Change Notification #: 112683 - 00
Change Title: Intel® Server System R2308BB4GC
PCN 112683-00, Product Design
Update System PSU Bracket
Date of Publication: October 30, 2013

Intel will implement the following change on Intel® Server System R2308BB4GC:

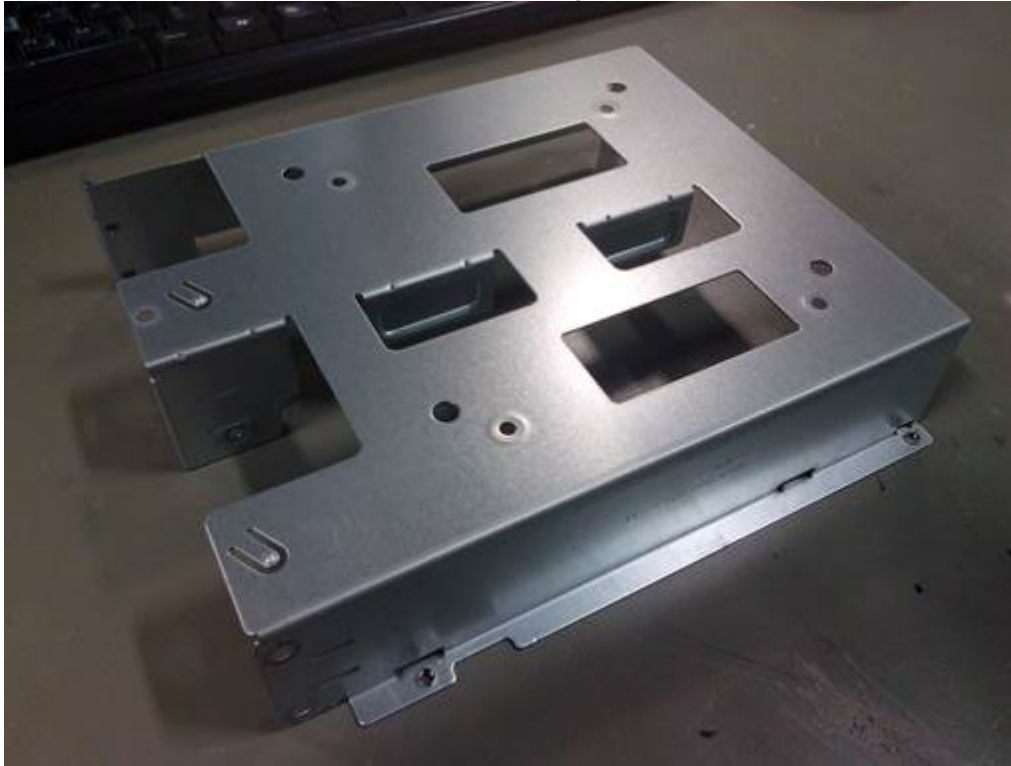
Update the Power Supply bracket to remove middle punch. Please refer to below pictures for details:

Pre-change:

Post-change:
